Catholic Television Network

Protection of Co-Channel and Adjacent-Channel ITFS Stations (Plan B Scenario)

**JOINT ENGINEERING EXHIBIT
IN SUPPORT OF COMMENTS TO
MM DOCKET NO. 97-217
CATHOLIC TELEVISION NETWORK**

Catholic Television Network
Proposed Notification and Equipment Test Zones

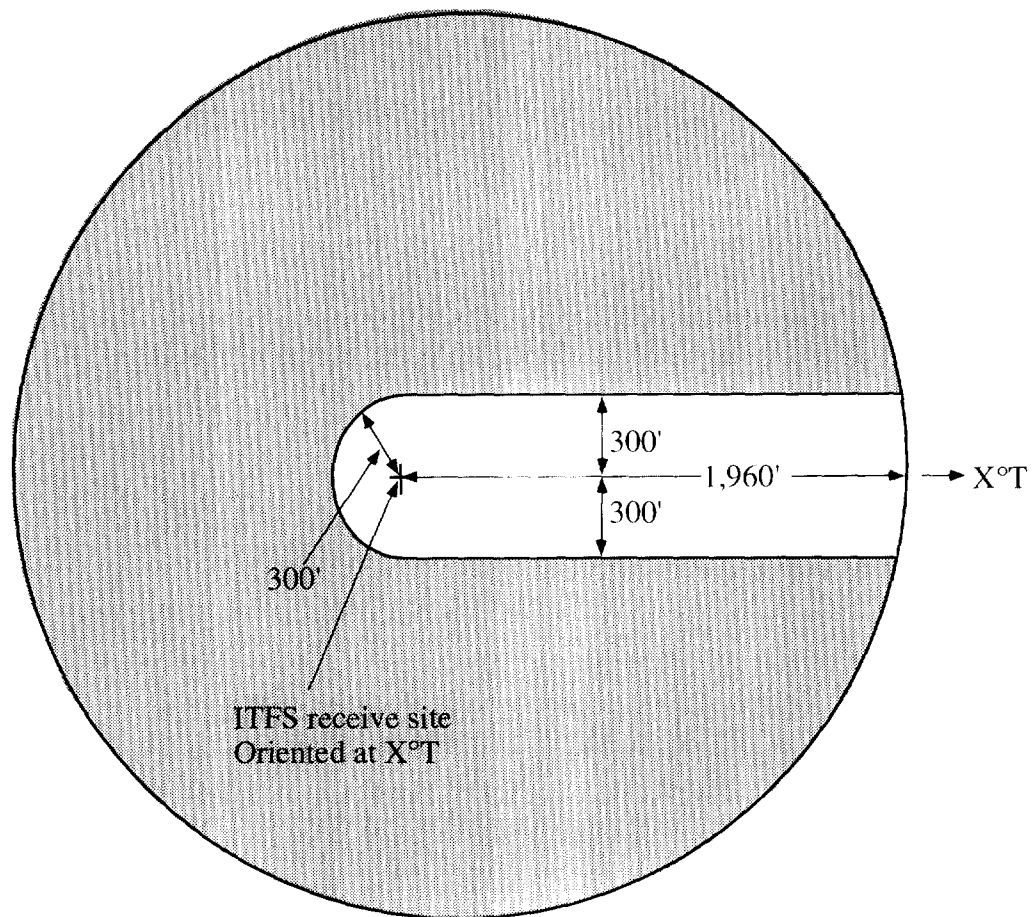
1. Figure showing proposed "notification" and "equipment test" zones around an ITFS receive site.
2. Figure showing the "Plan A" ITFS/Response Station spectrum.

Catholic Television Network
"Plan A" ITFS/Response Station Spectrum

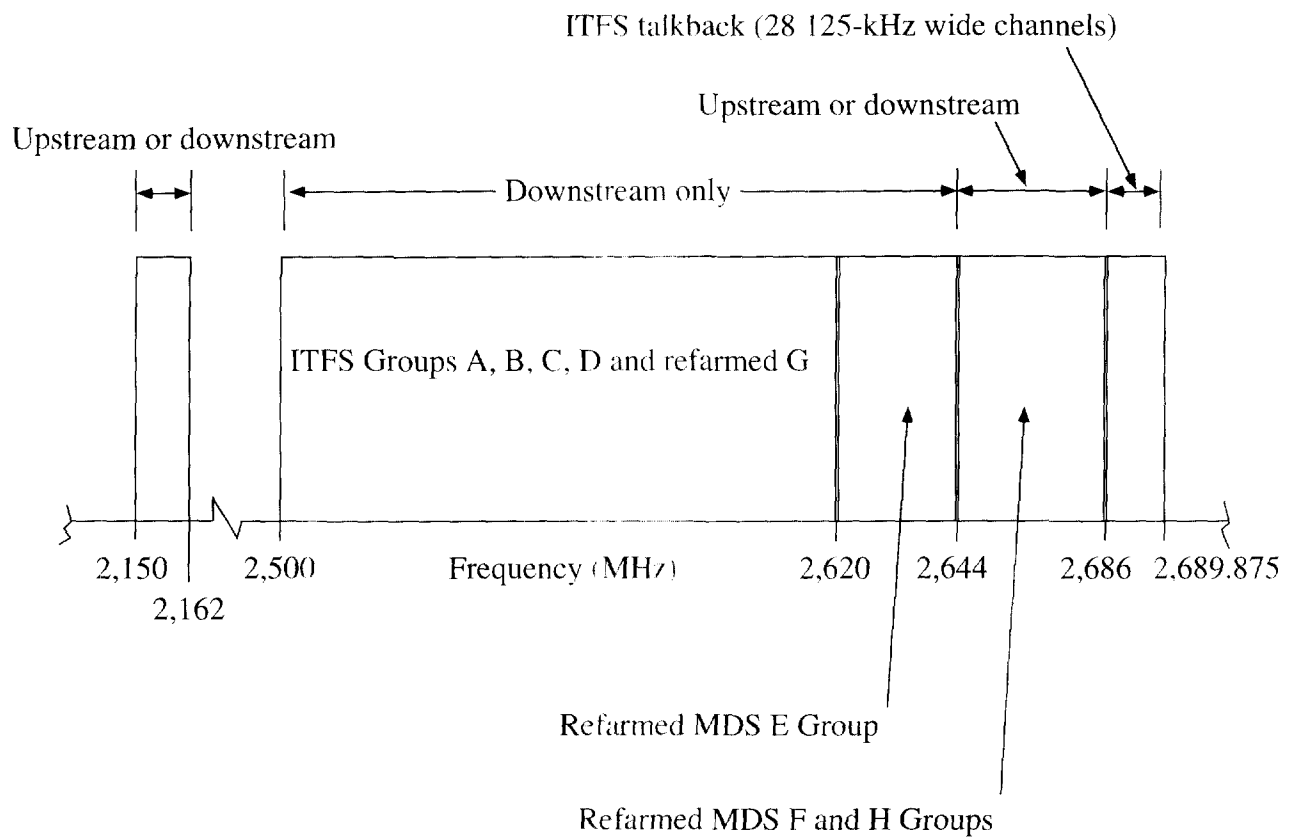
14. CTN originally proposed a 24 MHz guardband (now referred to as “Plan A” in these comments) to protect co- and adjacent-channel stations and other stations from BFO. With the criteria proposed above to mitigate BFO interference before it could become chronic, less guardband may be needed to protect co- and adjacent-channel stations.

18. Thus, guardbands would be necessary under either scenario in order to solve the co-channel and adjacent-channel upstream Response Station-into-downstream ITFS receive sites interference problem, but the 24-MHz wide guardband Plan A scenario would have the advantage of allowing practical use of filters, while the 6-MHz wide guardbands proposed under the Plan B scenario would have the advantage of not requiring ITFS G-Group licensees to change channels.

23. Even under the Plan A spectrum option proposed in these comments the relaxed Response Station transmitter spurious signal limits represent an interference threat. For example, since the ITFS-downstream to MDS-upstream guardband would be only 24 MHz wide, it follows that a Response Station transmitter could have a spurious signal falling on a frequency that would be seen as an in-band, co-channel interfering signal by an ITFS receiver. Even assuming the reduced Response Station EIRP of +48 dBm proposed in the NPRM, this still results in a spurious signal with an EIRP of +8 dBm. Since this could look like a co-channel interfering signal, a D/U ratio of 45 dB would apply. The interference potential of Response Station transmitters generating up to ten discrete spurious signals at up to +8 dBm EIRP each, of which at least two could be seen as in-band, co-channel interfering signals under the Plan A proposal suggested in these comments, or of which up to all ten could be seen as could be seen as in-band, co-channel interfering signals under the alternative 6-MHz guardband Plan B CTN proposal, are both unacceptable. And were the Commission to ultimately allow Response Station transmitters to have EIRPs of up to +63 dBm (2,000 Watts), then the allowable discrete-frequency spurious signal power level would increase to +23 dBm: this would then exceed the +21 dBm EIRP limit allowed by Section 74.985(g) of the existing ITFS Rules for Signal Booster Stations, but without the reasonable and necessary safeguards that the Rules require for Signal Booster Stations (*e.g.*, no co-channel or adjacent-channel ITFS receive sites within 1.61 kilometers, and prior notification to ITFS licensees within eight kilometers of the Signal Booster Station.)
